IN THE MATTER Private Plan Change Request
31 (PC31)

**SUMMARY OF EVIDENCE OF HUGH ANTHONY NICHOLSON
ON BEHALF OF WAIMAKARIRI DISTRICT COUNCIL**

URBAN DESIGN AND LANDSCAPE

9TH AUGUST 2023

Figure 2: Diagram of settlement with rectilinear block pattern showing various edge connections

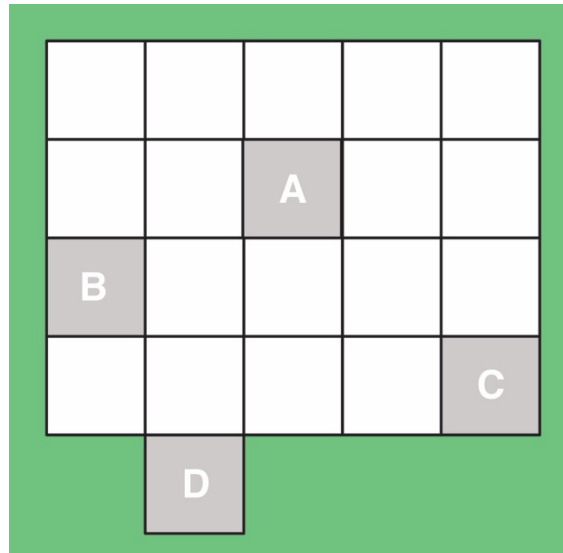
- 9.6 I consider that the proportion of a site boundary that adjoins an existing settlement is a useful measure of compactness and consolidation. Figure 2 shows a diagrammatic settlement pattern with rectilinear blocks and shaded areas indicating undeveloped blocks.

- 9.7 Block A has 100% of its boundary adjoining existing urban areas and developing this would clearly contribute to a compact and consolidated settlement. Block B has 75% of its boundaries adjoining existing urban areas and would similarly contribute to a compact and consolidated settlement. Block C has 50% of its boundaries adjoining existing urban areas, and in appropriate circumstances, such as a corner site, it would also contribute to a compact and consolidated settlement.

- 9.8 Block D has 25% of its boundaries adjacent to existing urban areas and creates an outlier or peninsula extending out from the town. I do not consider that Block D would contribute to a compact and consolidated urban form.

Figure 3: Diagram of Ohoka and PC31 with Ohoka blocks shown at half the density of PC31 blocks and with 18.75% of PC31 edges connected

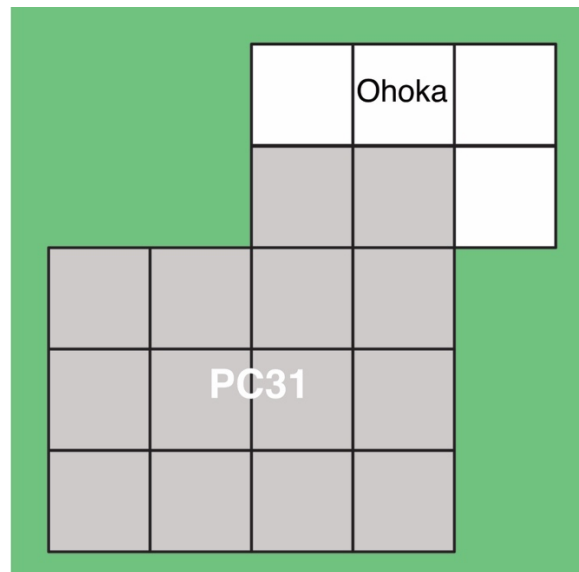
- 9.9 The PC31 site has approximately 17% of its boundary connected to the existing Ohoka settlement, and in my opinion does not contribute to a compact and consolidated urban form for Ohoka.

- 9.10 An equivalent diagram for Ohoka and PC31 would look more like Figure 3, assuming that the blocks in the existing Ohoka township are half of the density of the blocks in PC31. I agree with Mr Knott that PC31 could be more appropriately described as *“a new town within the rural area”*¹⁹.
